Facility Name: Dick Price Rd Transfer Station

Re: Response to Notice of Deficiency Letter – Type V Registration Application  
Dick Price Road Transfer Station, Registration No. MSW-40346  
RN101478790/CN601668486  
Tracking No. 31603368

**APPLICATION DEFICIENCIES TABLE**

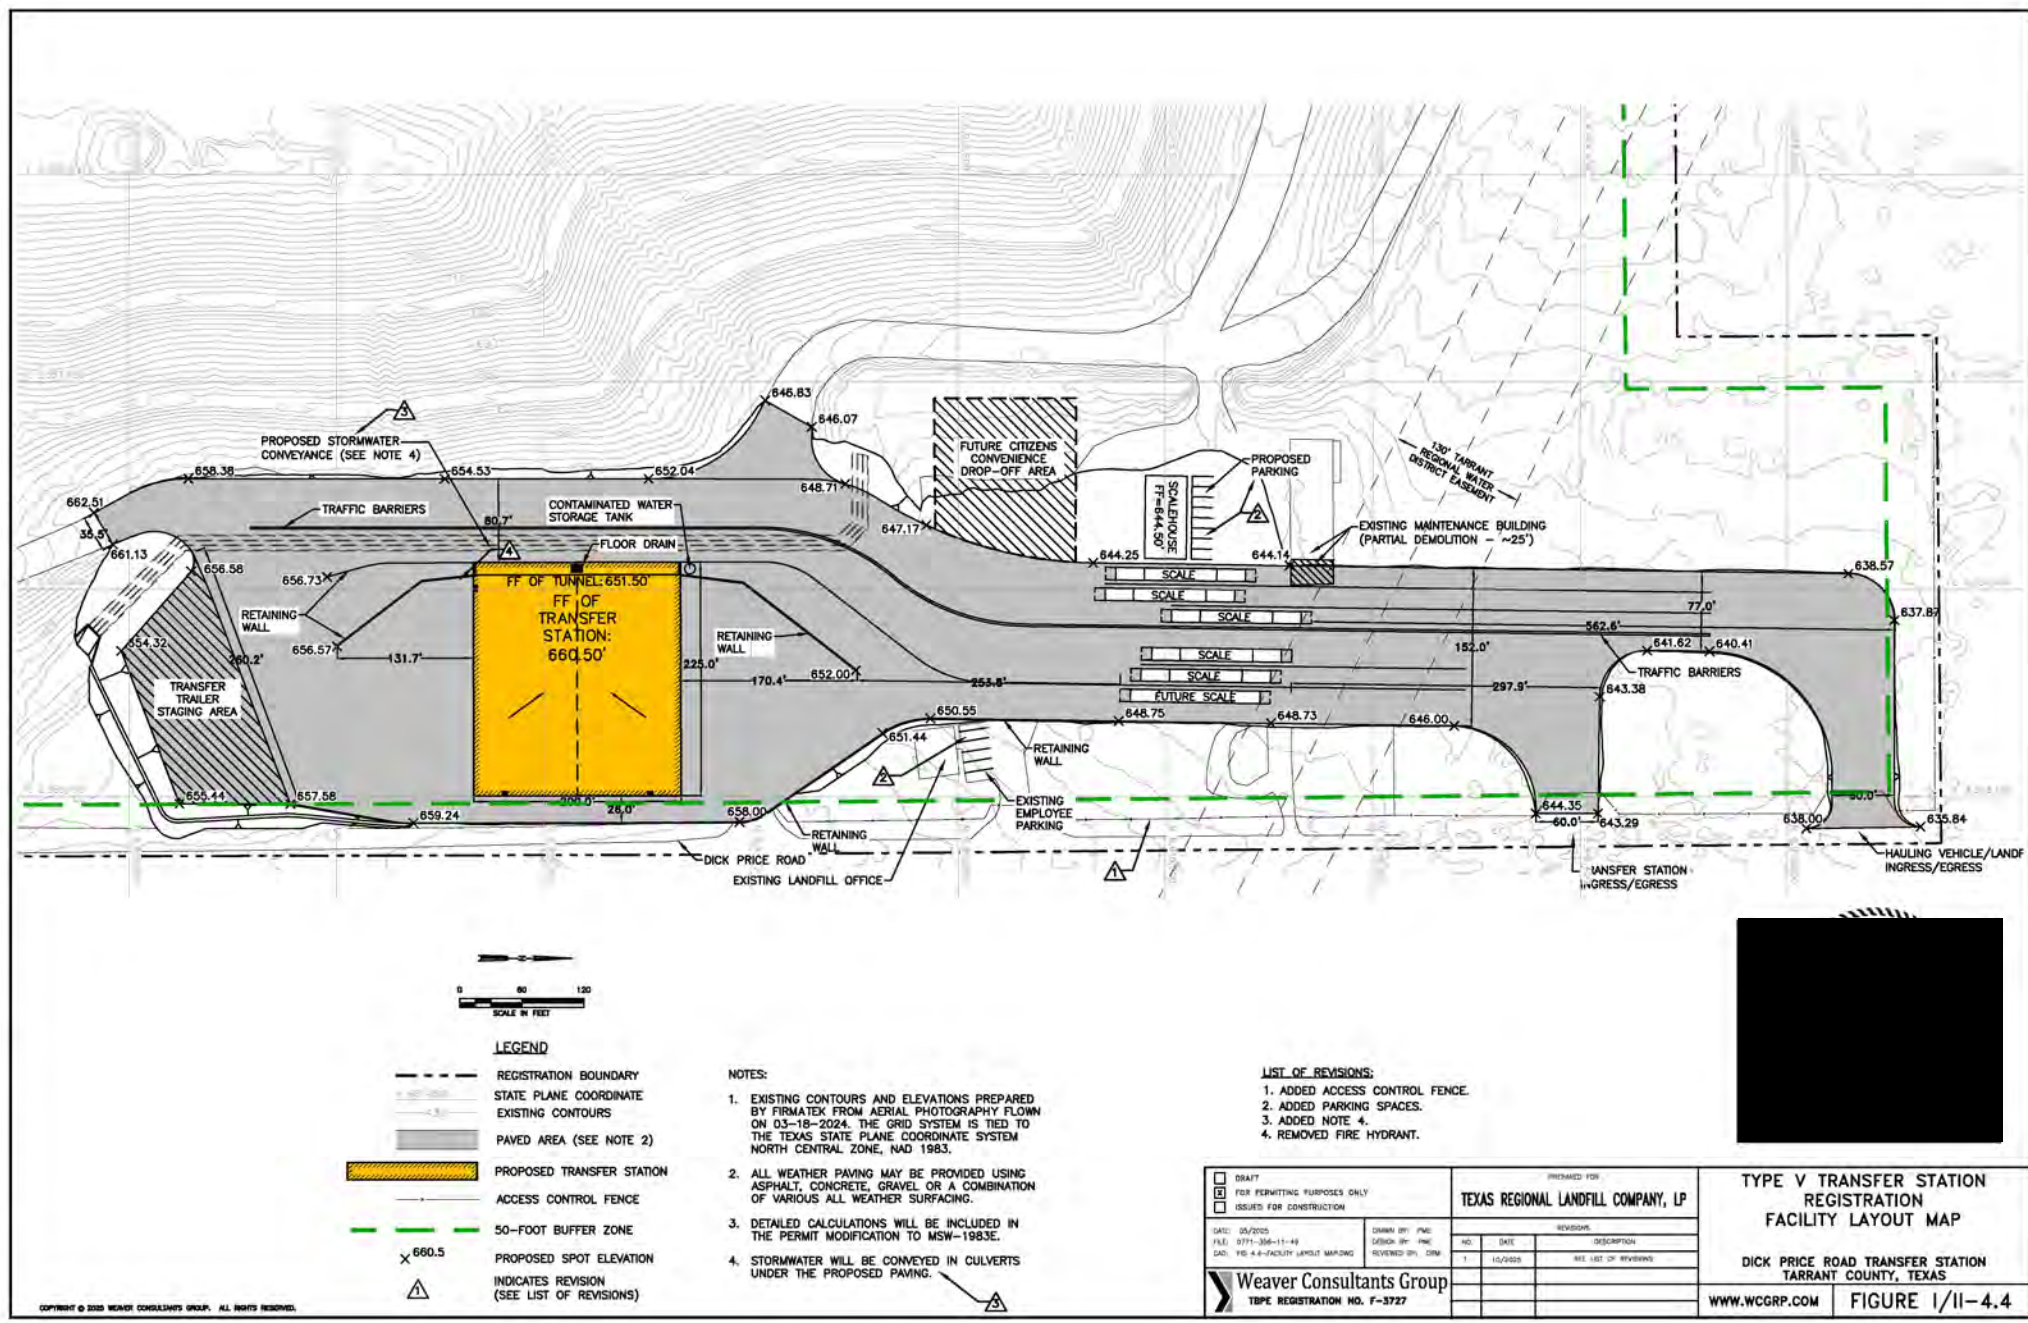
28	1057	Part IV, Section 8.1.3	330.223(b)	<p>The cited figures do not show vehicle parking areas except for the transfer trailer staging area. Revise or provide figures to show other parking, including employee parking, to be included. If no additional parking will be provided, please clarify in the NOD response.</p> <p><b>Response:</b> Part IV, Section 8.1.3 was revised to reference the correct figures showing the parking spaces. Figures I/II-4.4 and IIIA-1 have been updated to depict both new and existing parking areas at the existing infrastructure (landfill office), trailer staging area, and the scalehouse.</p>

- ADDED ACCESS CONTROL FENCE.
- ADDED PARKING SPACES.
- ADDED NOTE 4.
- REMOVED FIRE HYDRANT.

FIGURE III-2.1

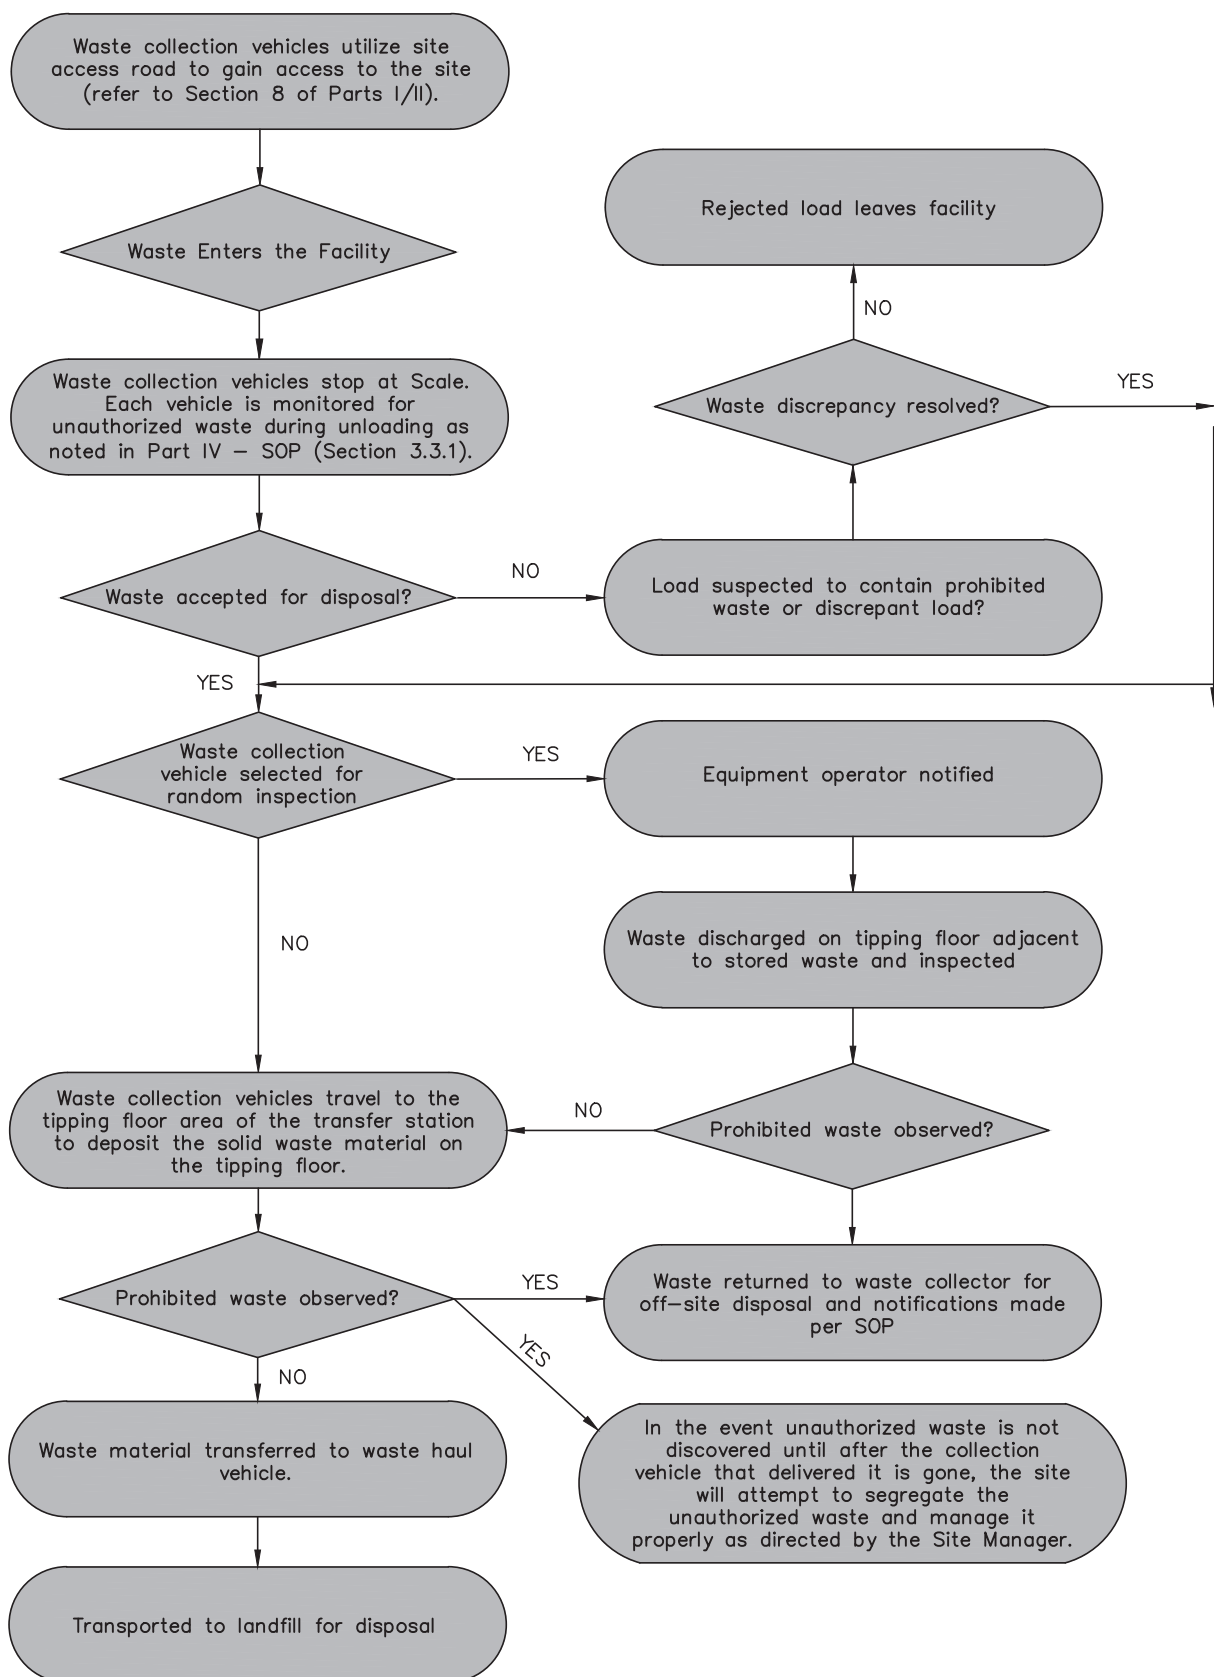
16	271	Part III	330.63(b)(2) and 330.63(b)(2)(A)	Checklist cites Figure III-2.1, but this figure could not be found. Provide the figure or indicate the page number in the Part III Table of Contents.  <b>Response:</b> Figure III-2.1, referenced in Part III, Section 2.2.1, has been included in the submittal and is identified on page III-5A of Part III.
17	273	Part III, Appendix A	330.63(b)(2)(B)	Provide or revise figures which indicate or explain the following. 1. Explain why some unloading trucks go between the retaining walls on the west side of the building while most appear to unload on the south side. 2. Explain the purpose of the transfer trailer route indicators (gold arrows). They do not appear to interact with the transfer station. 3. Explain how the transfer trailer staging area integrates into the workflow. 4. Explain why trucks are being conducted into the facility along a stormwater conveyance path. Revise to include the access fence as depicted in the legend.  <b>Response:</b> 1. Figure IIIA-2 has been revised to indicate that all unloading vehicles will access the transfer station by driving on the west side of the TS building, U-turn on the south side, drive through the TS building from south to north, and exit, heading north to the scales. 2. Figure IIIA-2 has been updated to indicate that the gold arrows depict landfill traffic patterns rather than transfer station traffic. Orange arrows

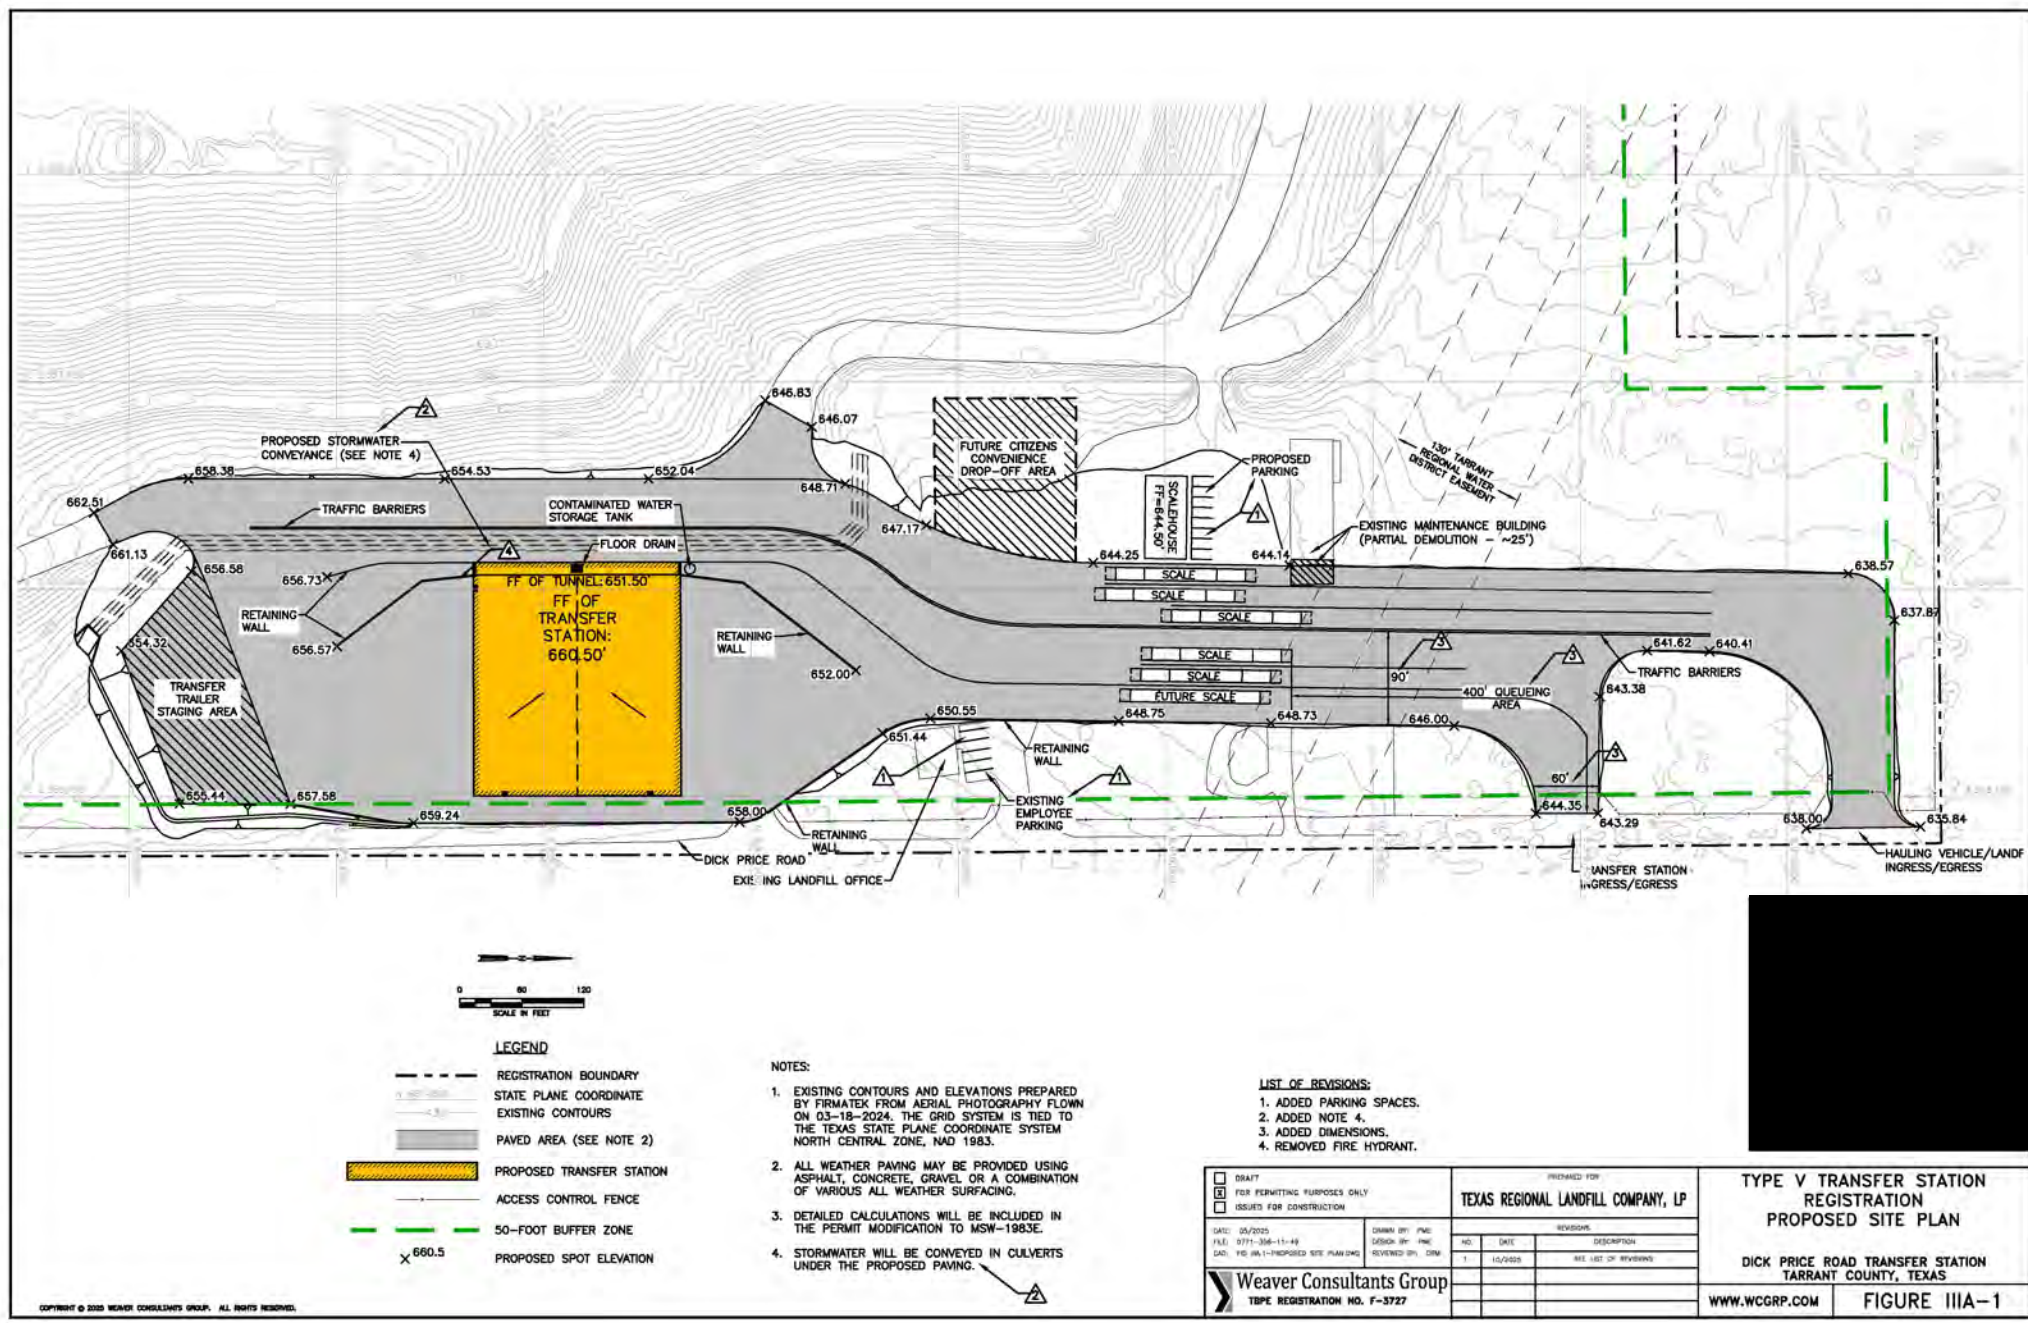
<p>have been added showing how transfer trailers will access the tunnel and utilize the staging area on the south side of the TS building.</p> <ol style="list-style-type: none"> <li>3. The transfer trailer staging area has been designated as a turnaround and parking area to facilitate efficient trailer movement into the loading tunnel and prevent congestion or conflicts with transfer station traffic circulation.</li> <li>4. Figures in IIIA have been revised to depict the access fence in accordance with the legend. The stormwater conveyance route is located within underground culverts, separate from vehicular access paths.</li> </ol>
18	275	Part III, Section 2.2.4	330.63(b)(2)(D)	<ol style="list-style-type: none"> <li>1. Describe the number, size, and spacing of the entry/exit ways used to service vehicles.</li> <li>2. Indicate if there will be any ancillary buildings attached to or part of the facility, such an office area or parking area.</li> </ol> <p><b>Response:</b></p> <ol style="list-style-type: none"> <li>1. Part III, Section 2.2.4 and Figure IIIA-1 were revised to include a description of the number, size, and spacing of the entry and exit ways used for servicing vehicles at the facility.</li> <li>2. The Dick Price Road Transfer Station includes a new transfer station building and a scalehouse building. Associated parking areas are shown in Figure IIIA-1.</li> </ol>

1. ADDED TRANSFER TRAILER ROUTE ARROWS.
2. REVISED LEGEND.
3. ADDED NOTES 4 AND 5.
4. REMOVED FIRE HYDRANT.
